Cobb County Community Development Agency
Zoning Division

Case # Z-62
Public Hearing Dates:
PC: 11-06-18
BOC: 11-20-18

FINAL ZONING STAFF RECOMMENDATION:
(Zoning staff member: Jason Campbell)

ZONING EXHIBIT
FOR
MCCONNELL GREEN NORTH
COBB COUNTY, GEORGIA
LAND LOTS 83 & 84 - 19th DISTRICT - 2nd SECTION

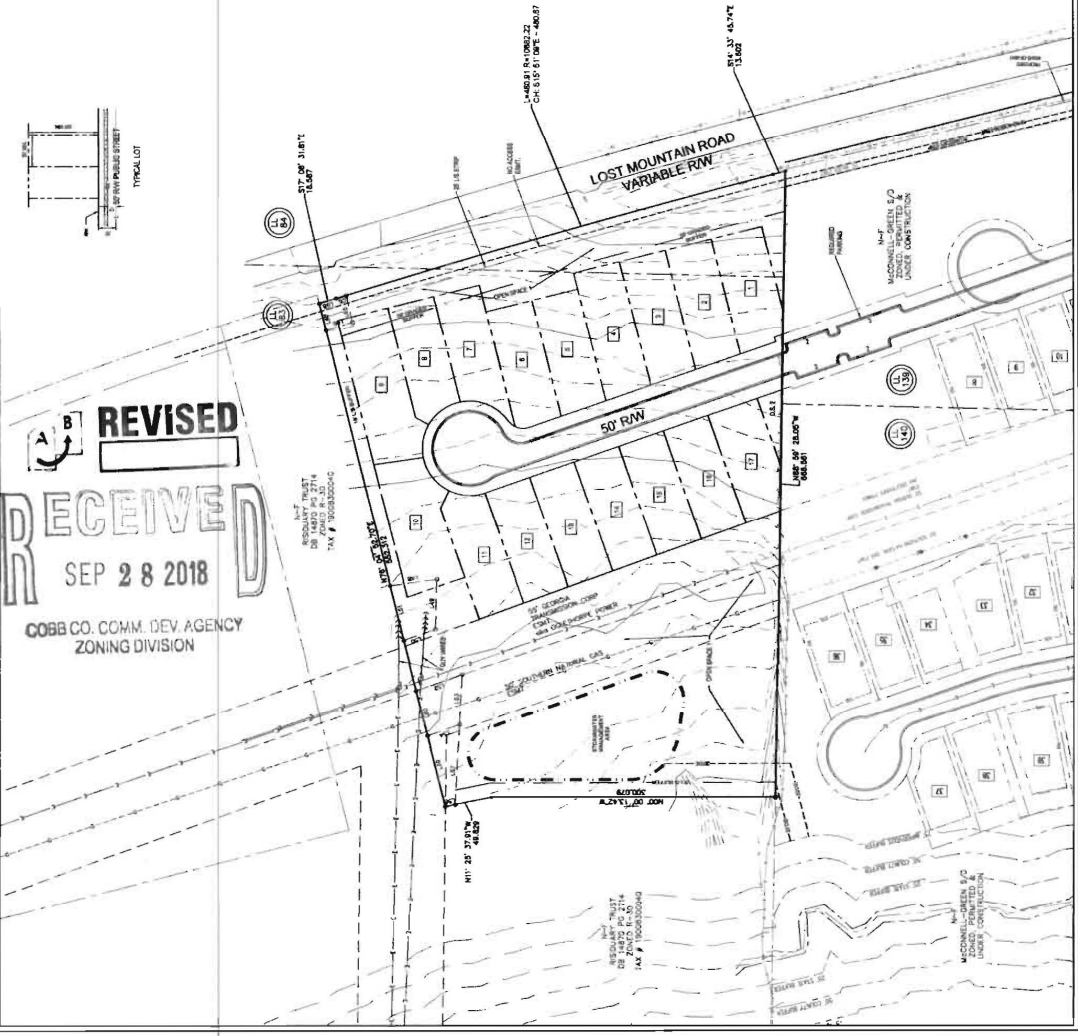
1. Waive all setbacks to zero and have 10 feet between buildings; and
2. Waive the landscape buffer abutting more restrictive residential zonings to the west and north from the required 20 feet to 15 feet.

Modifications will be required to incorporate the Cobb County Fire Marshal's Office comments.

1. Flood hazard: No
2. Flood hazard zone: Zone X
3. Drainage Basin: Tributary to Mill Creek No. 1
4. Wetlands: No
5. Streambank buffer zone: No
6. Stormwater discharges must be controlled not to exceed the existing capacity of the downstream storm drainage system.

7. Minimize the effect of concentrated stormwater discharges onto adjacent properties.
8. Developer must secure drainage easement(s) to receive concentrated discharges where none naturally exist.

9. Existing Lake Downstream – Woodward Pond (~2300' downstream). Additional BMP's for erosion & sediment control will be required.
10. Lake Study will be required to document pre- and post-development sediment levels within pond located on Woodward property to document any possible sediment impacts to pond.

11. Stormwater discharges through an established residential neighborhood downstream.
12. Project engineer must evaluate the impact of increased volume of runoff generated by the proposed project on existing downstream drainage system(s).

13. Special site conditions and/or additional comments:
 - Project engineer must evaluate the impact of the increased runoff volume generated by the proposed project on receiving stream and existing culvert at Pickens Road.

Additional sewer comments: Revision to McConnell Green S/D plans needed to eliminate cul-de-sac and bring water and sewer to Z-62 property

Lost Mountain Road is classified as an arterial roadway and according to the available information the existing right-of-way does not meet the minimum requirements for this classification.

Cobb County DOT SPLOST project Dallas Highway at Lost Mountain/Mars Hill Road (X2305) will require permanent easement on Lost Mountain Road along the frontage of this development.

1. Recommend applicant consider entering into a development agreement pursuant to O.C.G.A. 36-71-13 for dedication of the following system improvements to mitigate traffic concerns: a) donation of right-of-way on the west side of Lost Mountain Road, a minimum of 50' from the roadway centerline.

2. Recommend applicant be required to meet all Cobb County Development Standards and Ordinances related to project improvements.
3. Recommend curb and gutter along both sides and sidewalk along one side of proposed development roadway.

4. Recommend a 10' no access easement for the lots that border Lost Mountain Road.
5. Recommend removing and closing driveway aprons along Lost Mountain Road frontage that development renders unnecessary.

6. Recommend applicant coordinate with Cobb County DOT prior to development plan approval to ensure compatibility with the proposed SPLOST project – Dallas Highway at

Lost Mountain/Mars Hill Road (X2305). Permanent easements will be needed for grading and drainage improvements.
